ADDENDUM NO. 2
TO
BIDDING AND CONTRACT
REQUIREMENTS AND SPECIFICATIONS
FOR THE
LINDEN STREET OVER EXETER RIVER
BRIDGE No. 081/046
BRIDGE REPAIR
EXETER, NH
WP PROJECT NO. 20837D

**LINDEN STREET OVER EXETER RIVER
BRIDGE No. 081/046
BRIDGE REPAIR**

ADDENDUM NO. 2

WP PROJECT NO. 20837D

TYPICAL FACING CORNER BAR DETAIL (BID ALT. 1)
SCALE: NTS

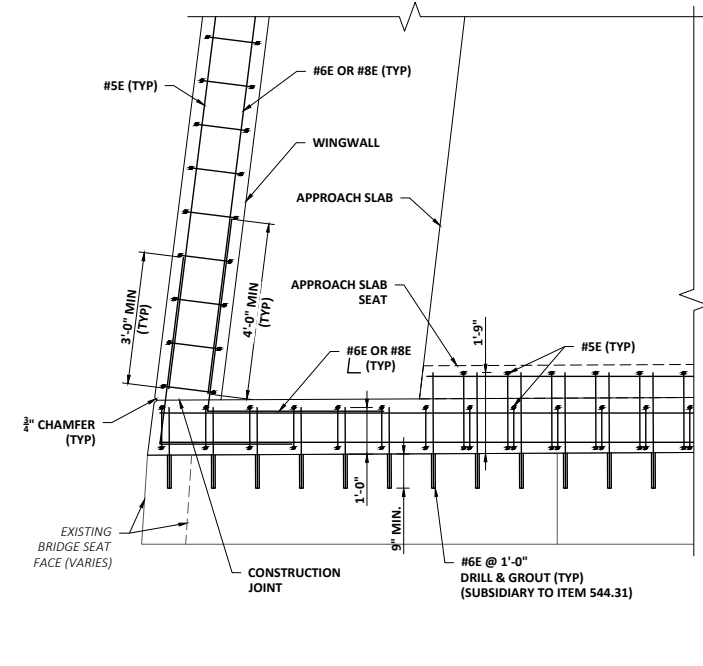
Q: Is concrete facing as shown in the bid alternate non-structural?

A: Yes.
